**Town of Rotterdam
Planning Commission
January 20, 2026**

2. Primax Properties, LLC (Contract Vendee) – 774-778 Duanesburg Road.

**RE: Proposed Development
774-778 Duanesburg Road (NYS Route 7)
Rotterdam, NY 12306
LaBella Project # 2241303.04**

**Re: Response to Comments Summary
Proposed Development
774-778 Duanesburg Road (NYS Route 7)
Rotterdam, NY 12306
Labella Project # 2241303.04**

Conceptual Elevation
Rotterdam, NY
October 23, 2025

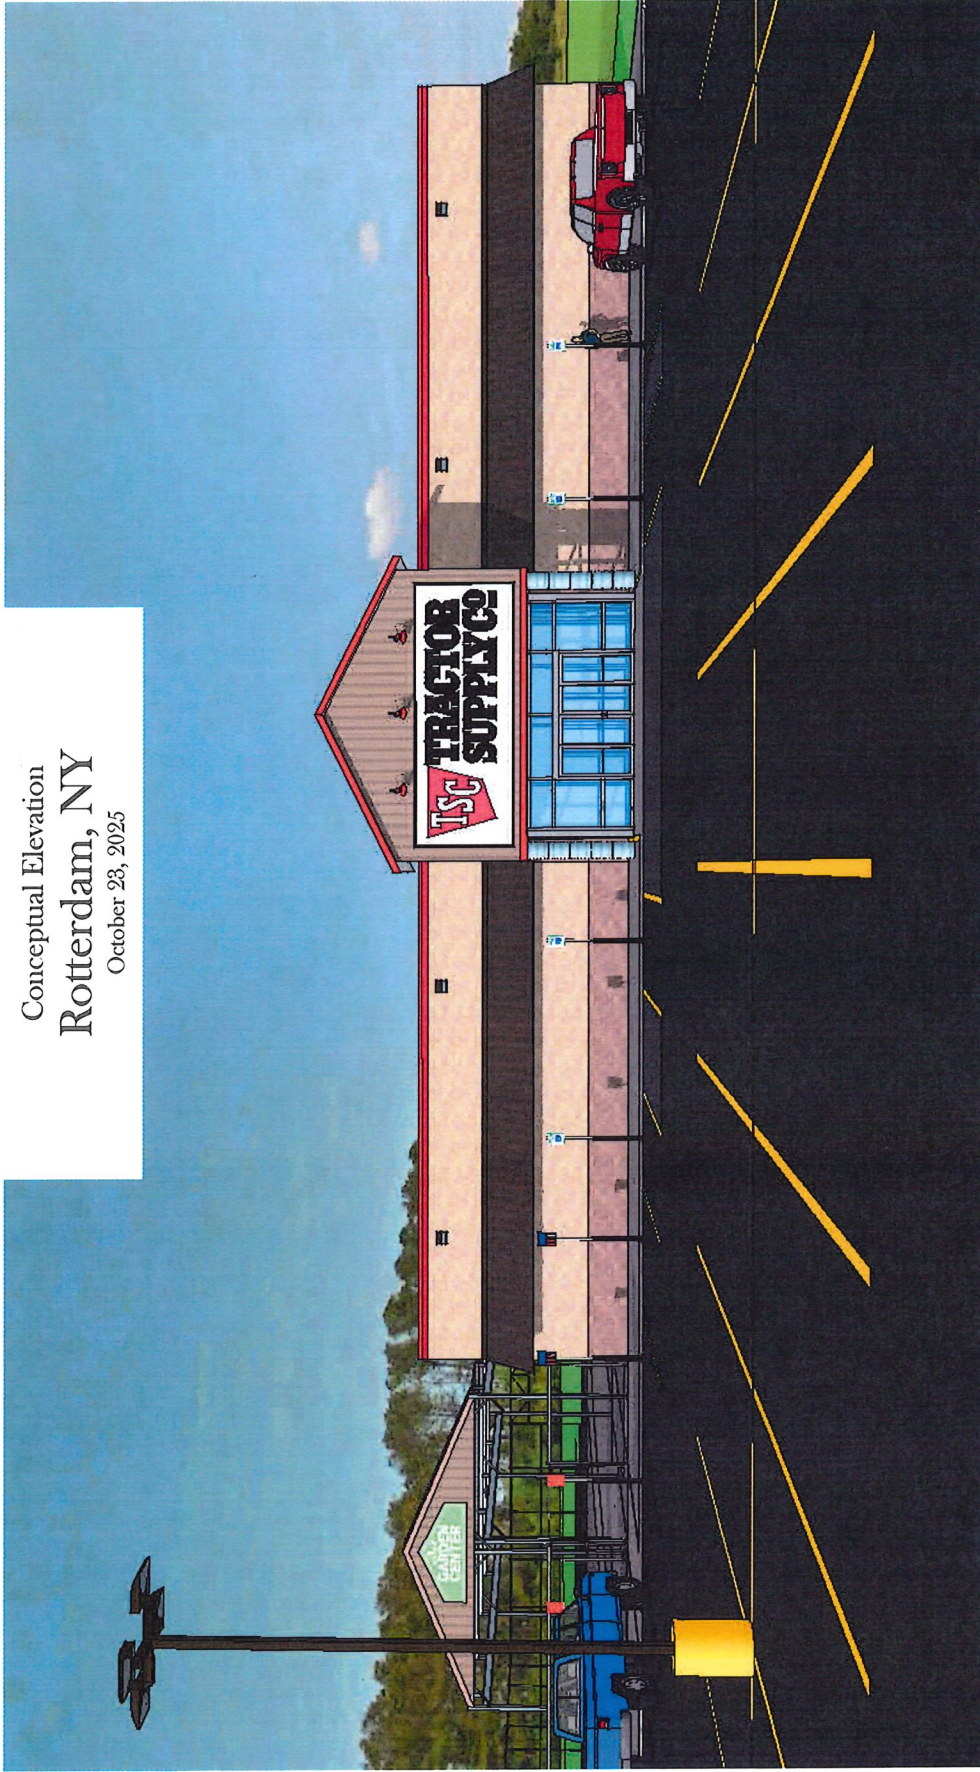
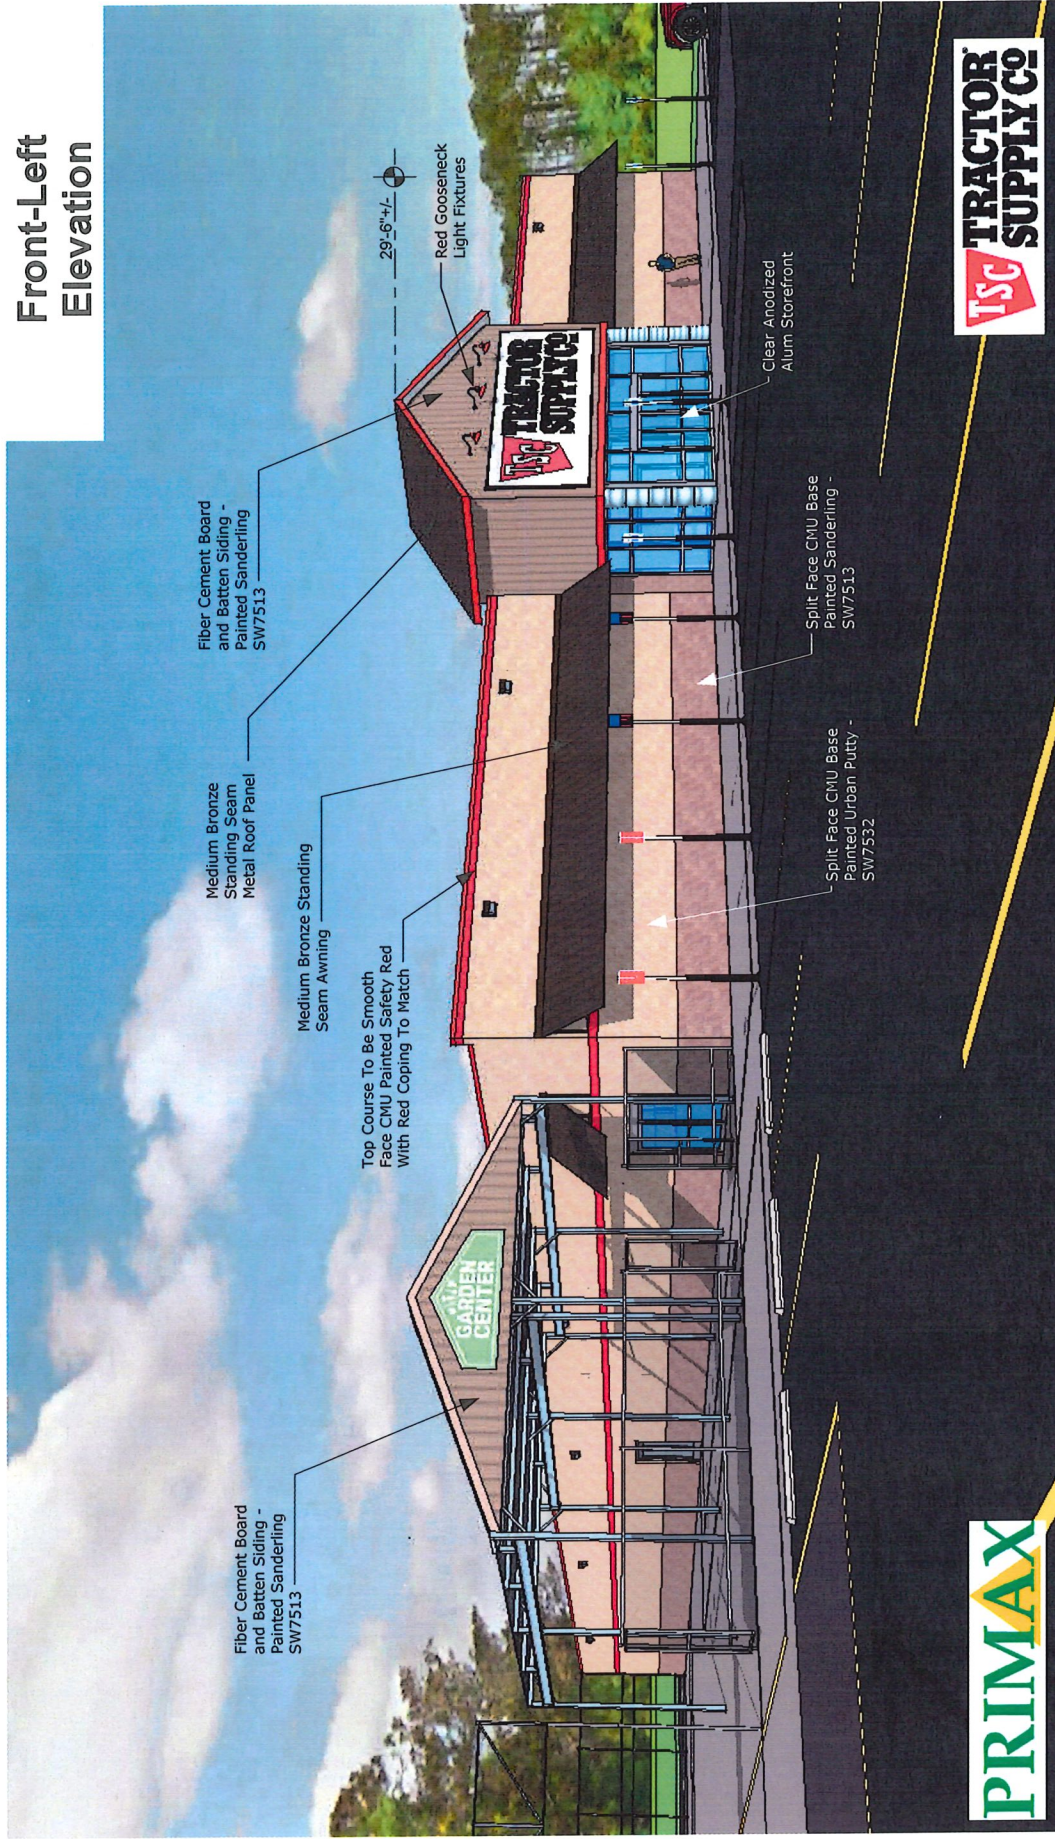
1. See enclosed comment response letter from Bohler dated January 2, 2026 and TDE review letter from LaBella dated January 15, 2026.
2. Landscaping (trees) and vinyl privacy fencing should be added to the northern property boundary with the Lands N/F of Dykeman.
3. Eliminate low lying landscaping island on the southwest corner of the paved parking area and replace with trees/grass for ease of maintenance.
4. Privacy fencing should be extended along the western property boundary with the Lands N/F of Inglis.
5. Center islands in parking lot should be curbed and contain two (2) deciduous trees in each island. Consideration should be given to add landscaping or greenery along building.

- SP 1-3. Applicant to provide building elevation for review.

Building elevations are attached with this submission as requested.
